**MINUTES OF
58th MEETING OF EXPERT GROUP ON ZOO DESIGNING
OF CENTRAL ZOO AUTHORITY
HELD ON 19th FEBRUARY, 2015**

The 58th Meeting of Expert Group on Zoo Designing of Central Zoo Authority was held under the Chairmanship of Shri Vinod Ranjan, Additional Director General of Forests (Wildlife) cum Member Secretary, CZA in the office of Central Zoo Authority at Hotel Janpath, New Delhi on 19th February, 2015. The list of participants is annexed at **Annexure – I(A) & (B)**. Following agenda items were taken up for discussion:

PROJECT PROPOSED PLAN OF CONSTRUCTION JACKAL ENCLOSURE AT ROHTAK ZOO, (HARYANA)

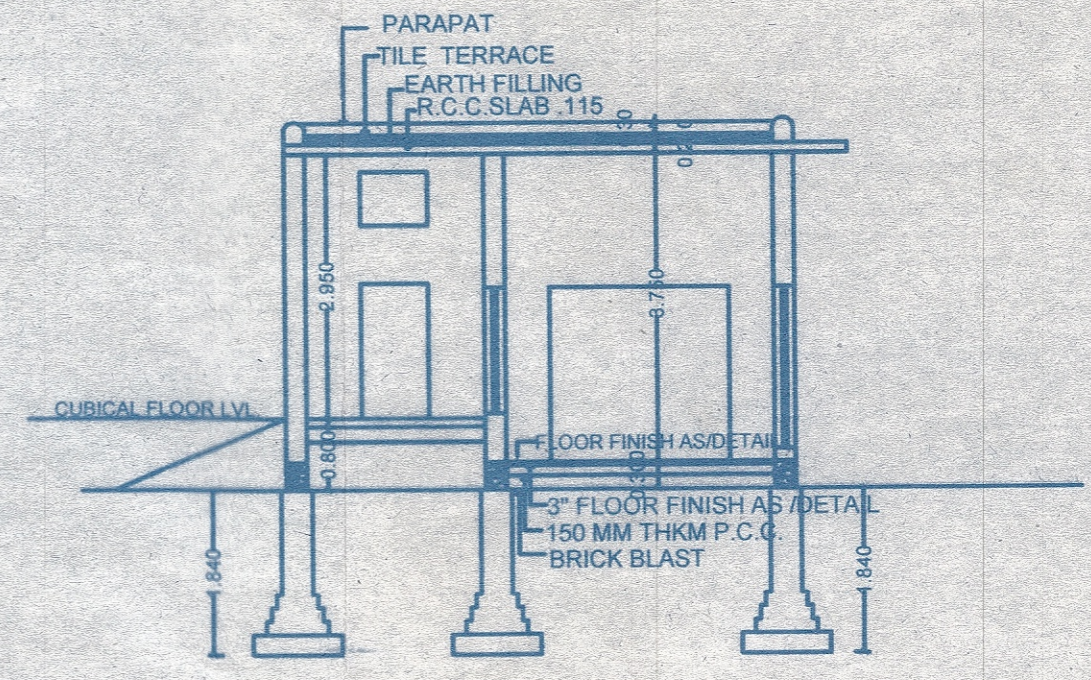
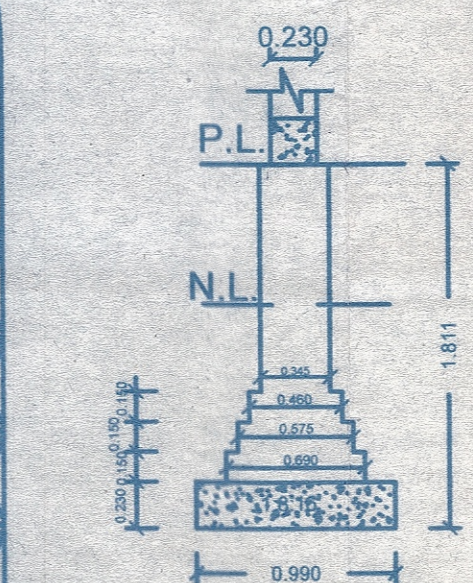
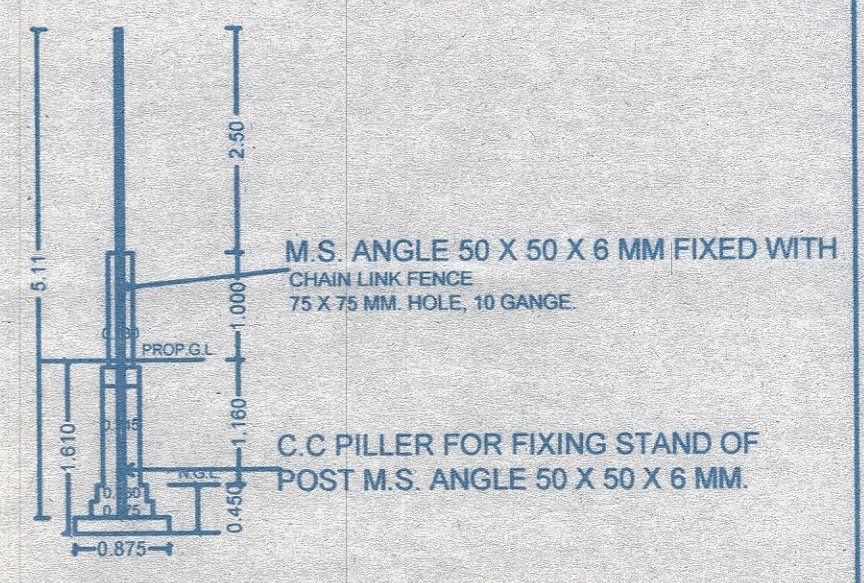
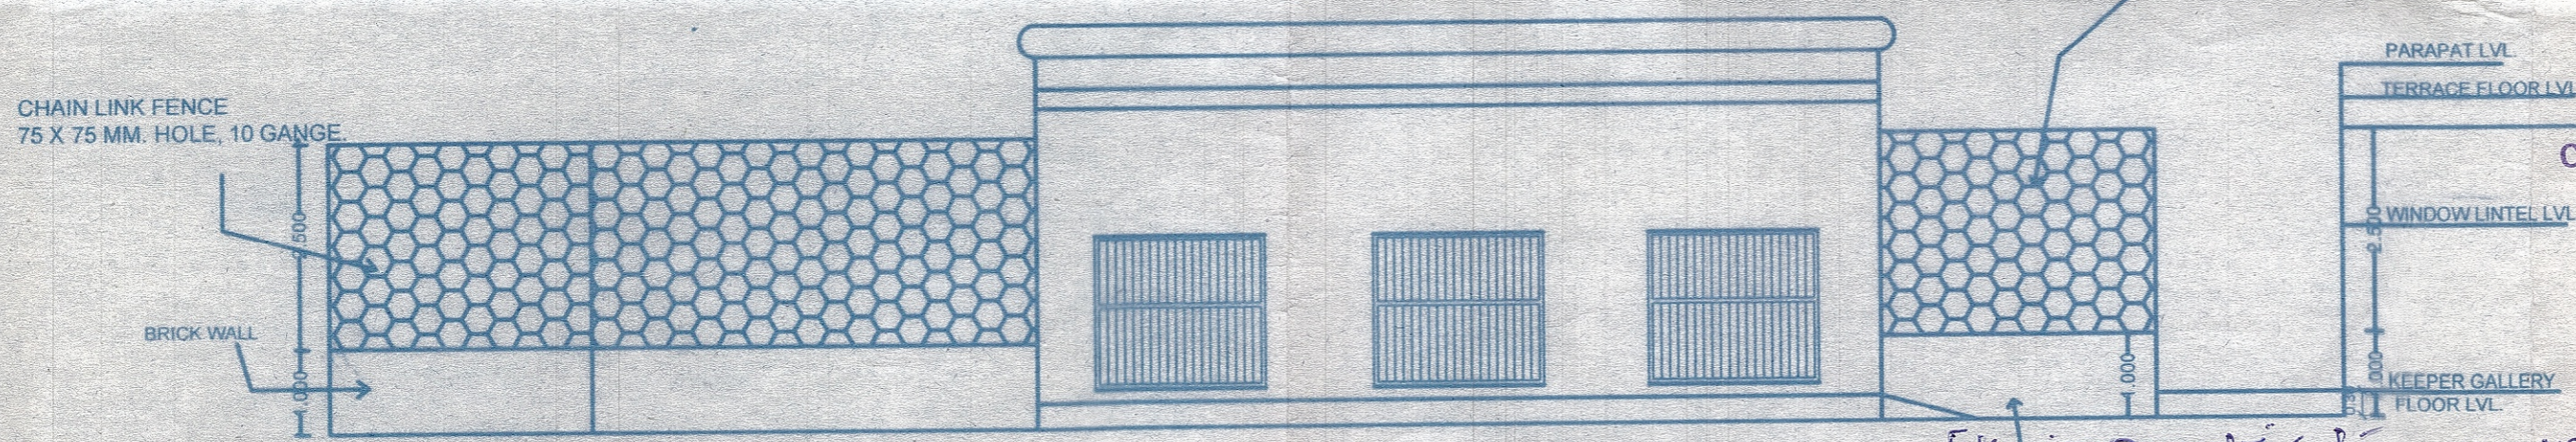
A. Construction of enclosure for Jackal (revised design):

The design was scrutinized and approved subject to compliance of following conditions:

- i. Three strings of barbed wire are to be fixed at top of fence inclined at an angle of 120° .
- ii. Size of chain-link fence should be 5.0 x 5.0 cm. / 8 guage.
- iii. Size of kraal should be 40 Sq.mts.
- iv. Size of keepers' gallery should be 2 mts wide.
- v. The height of chain-link mesh / fence from the ground level should be 2.50 mts.

- Following brick wall specifications are needed:
1. Three strings of barbed wire to be fixed at top of fence inclined at 120 degree
 2. Size of chain link fence
 3. Size of Krall should be 40 sq. mt.
 4. Size of keeper gallery should be 2 mt wide
